Technical Service Bulletin

SUBJECT: BATTERY MANAGEMENT UNIT (BMU) AND TRACTION BATTERY - SERVICE MANUAL REVISION			No: TSB-24-54-003
			DATE: September 2024
			MODEL: Outlander Plug-in Hybrid
CIRCULATE TO:	<input type="checkbox"/> GENERAL MANAGER	<input checked="" type="checkbox"/> PARTS MANAGER	<input checked="" type="checkbox"/> TECHNICIAN
<input checked="" type="checkbox"/> SERVICE ADVISOR	<input checked="" type="checkbox"/> SERVICE MANAGER	<input checked="" type="checkbox"/> WARRANTY PROCESSOR	<input checked="" type="checkbox"/> SALES MANAGER

This TSB provides corrections to the Battery Management Unit (BMU) and Traction Battery in the Electric Power Train section of the applicable Service Manuals.

2023-2025 Outlander Plug-in Hybrid

BATTERY MODULE CHECK

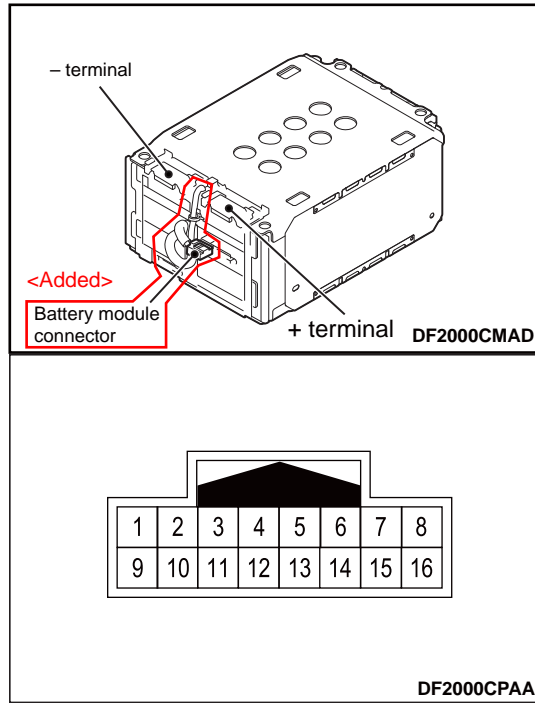
Required Special Tools: ~~Corrected~~

1. ~~Using the special tool check harness (MB991219)~~ ~~measure the voltage between the + and - terminals of the battery module , and between the following terminals of the battery module connector.~~

(1) Battery module No. 1, 2, 7 and 8 (14 cells)

Terminal (+)	Terminal (-)	Standard value
+ terminal	- terminal	44.03 ± 14.8 V
+ terminal	9	3.145 ± 1.06 V
9	1	
1	10	
10	2	
2	11	
11	3	
3	12	
12	4	
4	13	
13	5	
5	14	
14	6	
6	15	
15	7

(2) Battery module No. 3, 4, 5 and 6 (10 cells)

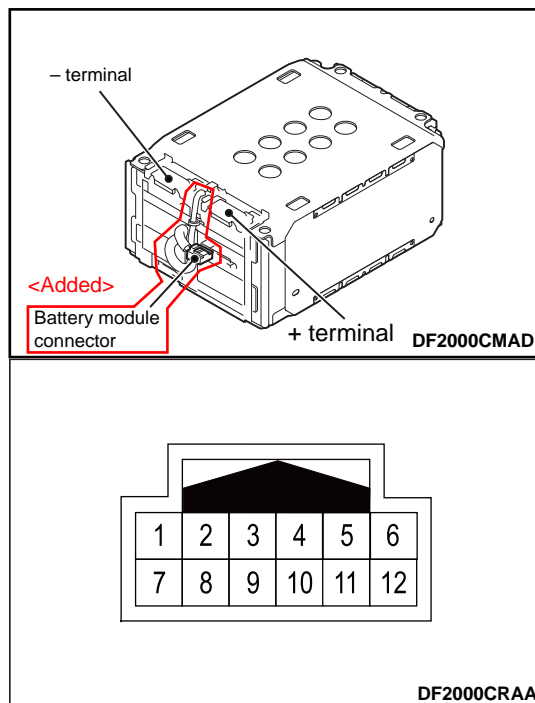
2.If the check result deviates from the standard value, replace the drive battery.

Terminal (+)	Terminal (-)	Standard value
+ terminal	- terminal	31.45 ± 10.6 V
+ terminal	7	3.145 ± 1.06 V
7	1	
1	8	
8	2	
2	9	
9	3	
3	10	
10	4	
4	11	
11	5
